2007 XL Engine Guard Installation

As recently communicated in Service Bulletin M-1200A, there is a clearance issue on 2007 Sportster model motorcycles that have had the voltage regulator relocated by using the 0128 Recall kit #94507, which interferes with installation of engine guard #49060-04.

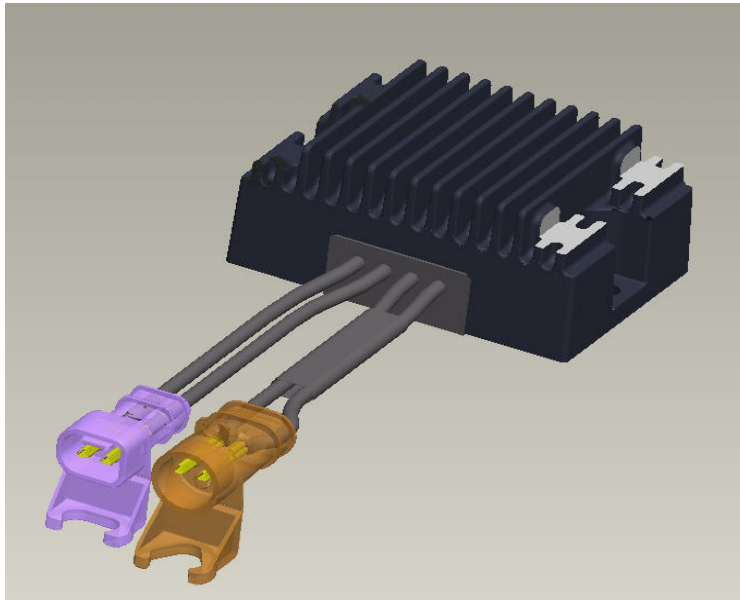
The following is a procedure that would apply only if a customer has had Recall kit #94507 installed and at a later date decides to have the P&A engine guard installed.

If you have the capabilities, you may remove the regulator and machine the bottom two cooling fins to a depth of .350", measured from the peak of the cooling fins, to provide clearance. Please refer to the attached drawing.

To remove material from the regulator case, we suggest the use of a mill, or another suitable method that will not make the part cosmetically displeasing to the customer. Removal of the material as described will have no impact on the performance or durability of the regulator. This procedure will allow proper fitment of the engine guard and takes less than ½ hour to complete.
